SECOND / THIRD READINGS SUMMARY SHEET

ZONING CASE NUMBER: C14 C814-06-0109 (Lakeshore PUD)

ZONING CHANGE REVIEW SHEET

CASE: C814-06-0109 (Lakeshore PUD)

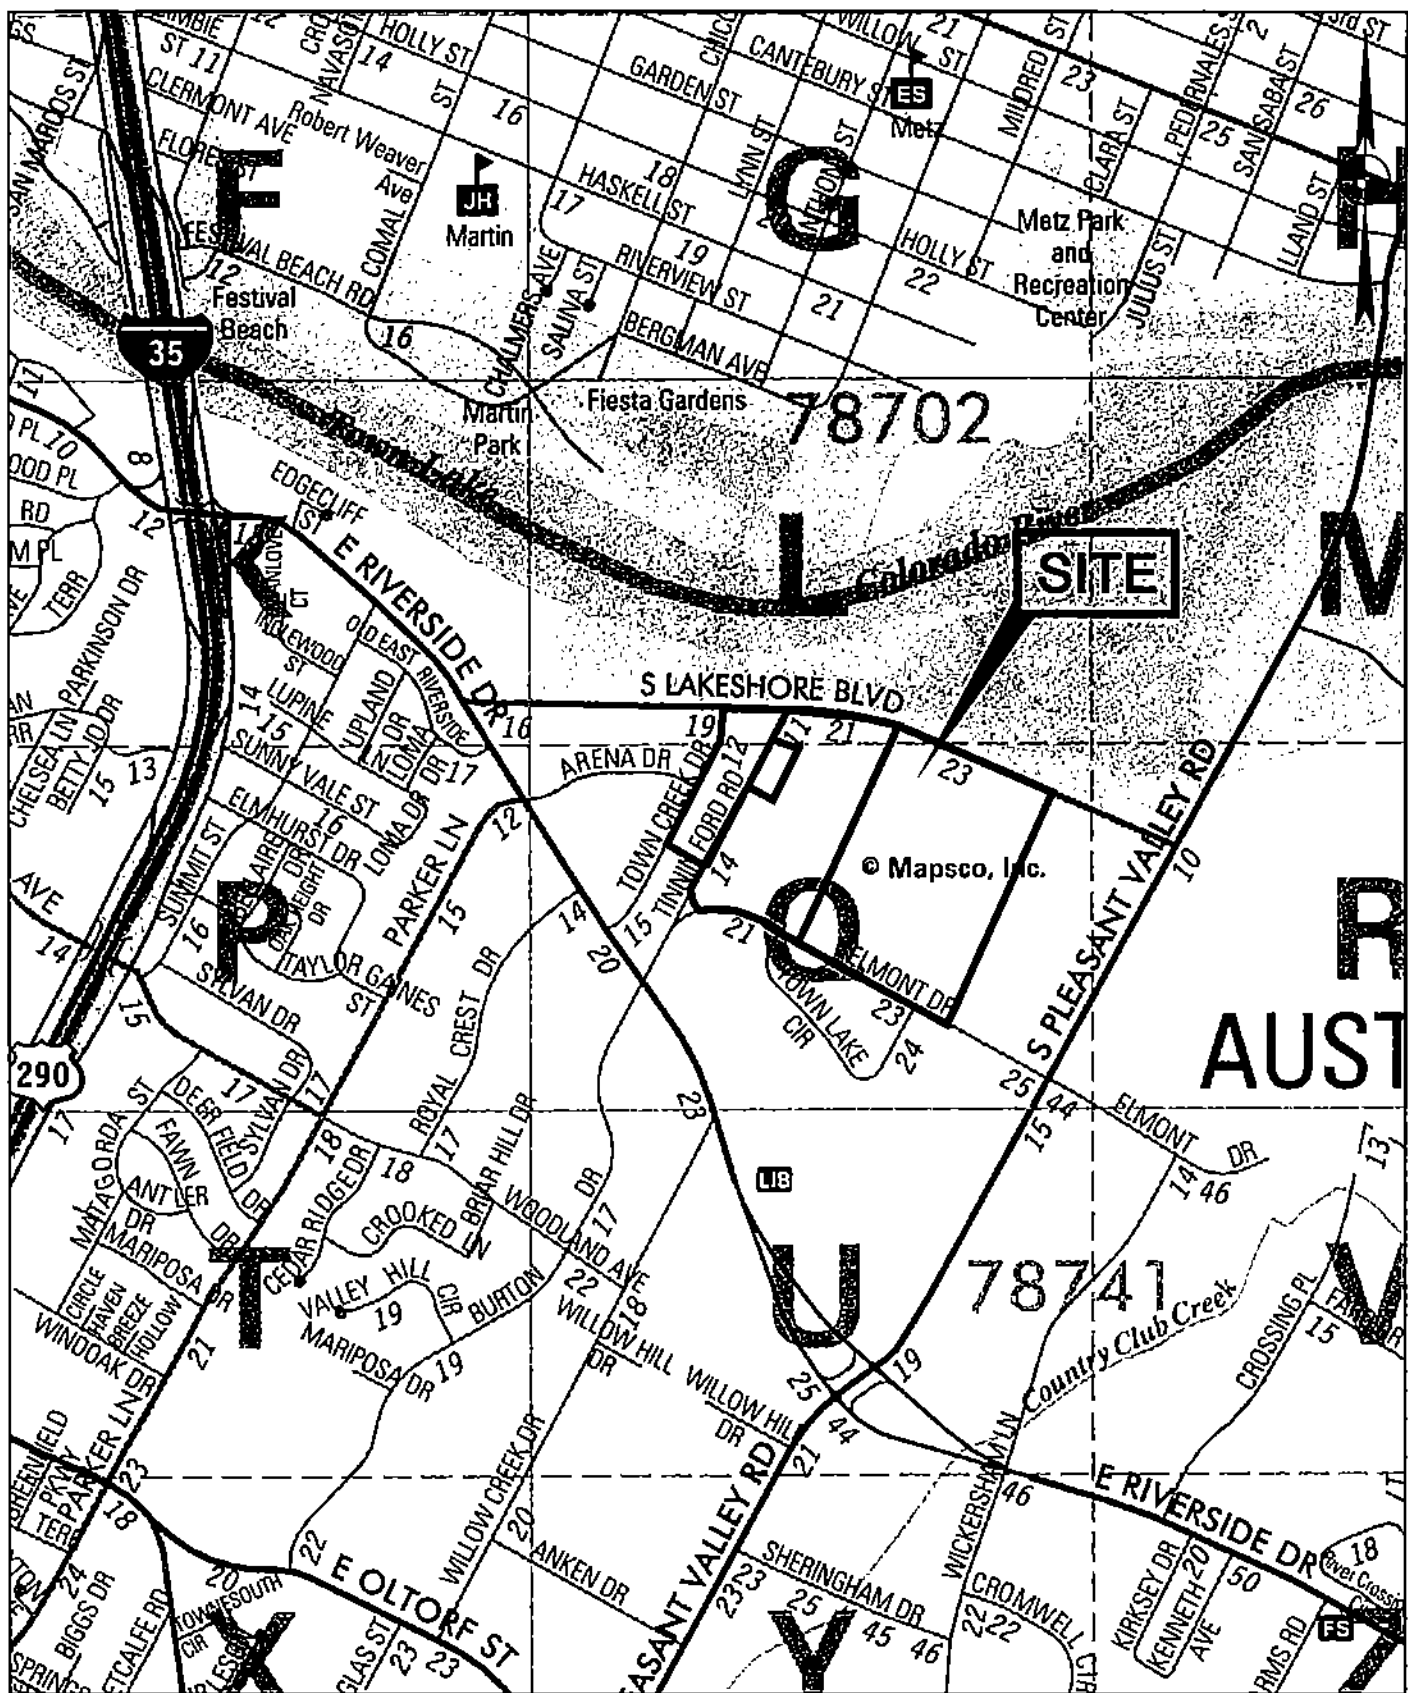
- ZN3. Accommodation for a future pedestrian easement is encouraged between the northern internal east-west street (which currently runs from the main internal north-south internal street and ends in a cul-de-sac) and the parkland to the east of the project.

Response from applicant: See attached letter 11/02/06. Noted. Circulation within the development for residents and the community is important to the success of the project. Sidewalks, streetscape, and trails within the development are proposed to provide access to Town Lake for the public.

EXHIBIT A LAND USE PLAN

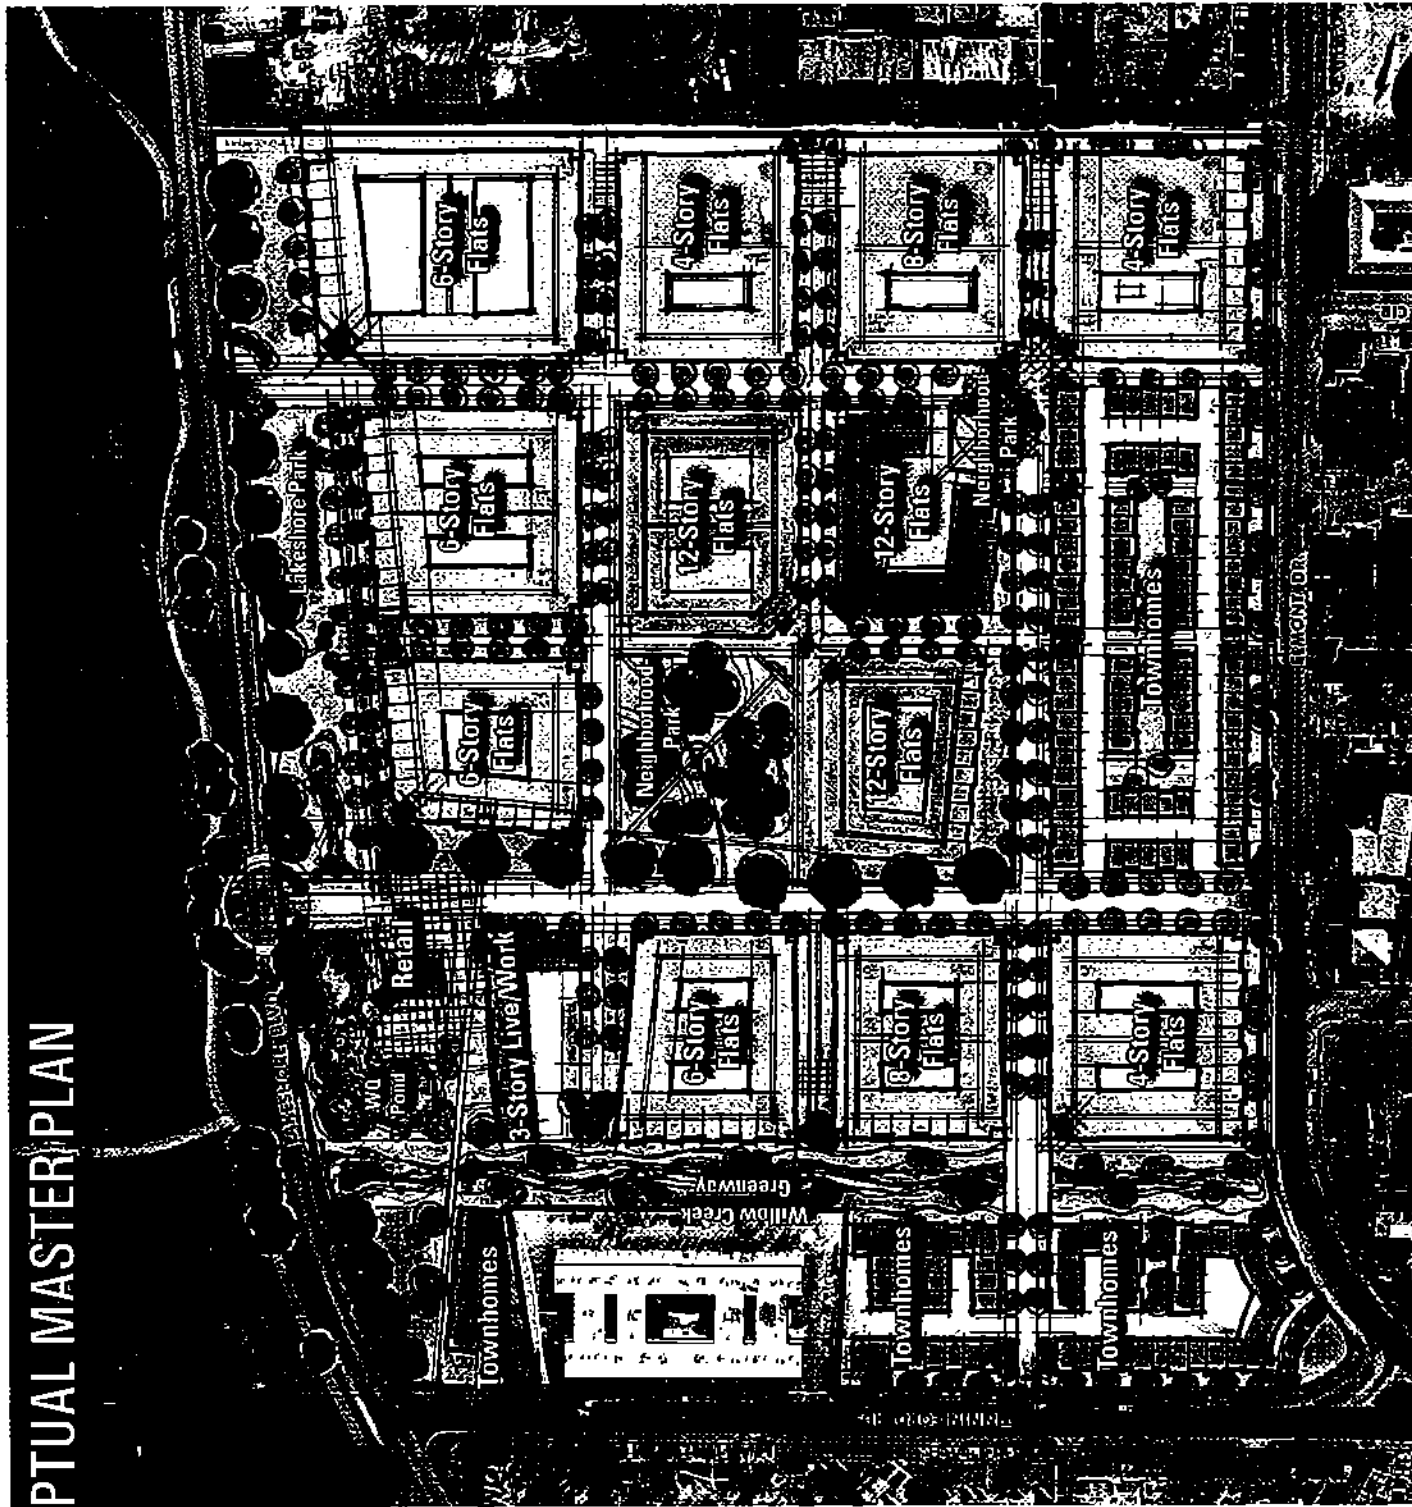
2. **PUD Note 2** note the first sentence of should read as follows: "The MF-6 site development standards are applicable to Lakeshore PUD."
3. **PUD Note 9** on the PUD Notes states that private utilities, including water and waste water, be permitted to cross lots. This note should be removed.

4. **PUD Note 10** on the PUD Notes should be clarified with the addition “as determined by the City of Austin”.
5. **PUD Note 13** needs to be clarified by adding a second sentence “No development is permitted in the 100 year floodplain.” Please show the 100 year floodplain on the **Land Use Plan**.

6. **PUD note 15**. The Grow Green plant lists will be included as exhibits.
7. The Land Use Plan indicated “internal driveways”. Please amend **PUD Note 24**, adding the following to the end of the first sentence: “...shown on the Land Use Plan as private driveways”.

- EV 7 Please clearly show and label all 100-year floodplain, waterway centerlines, and CWQZ.

EV 7 Please clearly show and label all 100-year floodplain, waterway centerlines, and CWQZ.

Response from applicant: See attached letter 11/02/06. The revised PUD plan shows the 100 year floodplain and CWQZ

Response from applicant: See attached letter 11/02/06. The revised PUD plan shows the 100 year floodplain and CWQZ
